**QUALITY ASSURANCE -- NON-CONFORMANCE REPORT**

**Report No:** NCR-000296

**Component:** OBG Segment Splice 1AE/1BE

**Reference Description:** Welding in Downward Progression, Weld Joint OBE1A-009

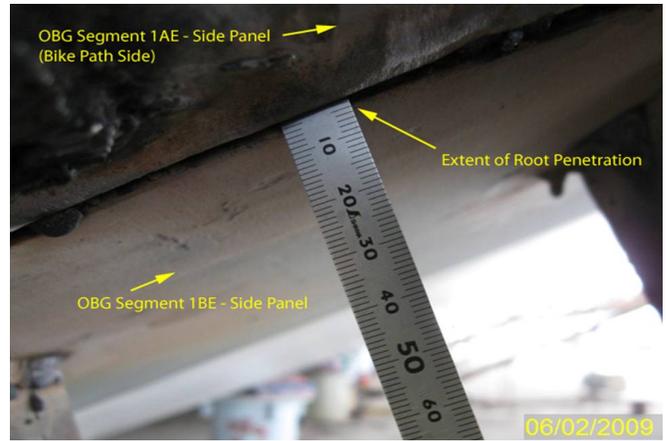
Caltrans Quality Assurance (QA) Inspector observed welding being performed in a downward progression on side panel splice weld OBE1A-009 (OBG Segments 1AE to 1BE). The vertical weld progression should be upwards per AWS D1.5 requirements.

AWS D1.5 2002, Section 4.14.1.7: "The progression for all passes of vertical position welding shall be upwards, unless a downward progression shall be qualified by tests approved by the Engineer."

The proposed resolution is acceptable. An internal ZPMC NCR was written, and the welder received additional training. Also, the weld in question has been accepted by VT, MT, and UT as shown in the attached documents. The Department concurs that Non-Conformance ZPMC-0270 is closed.
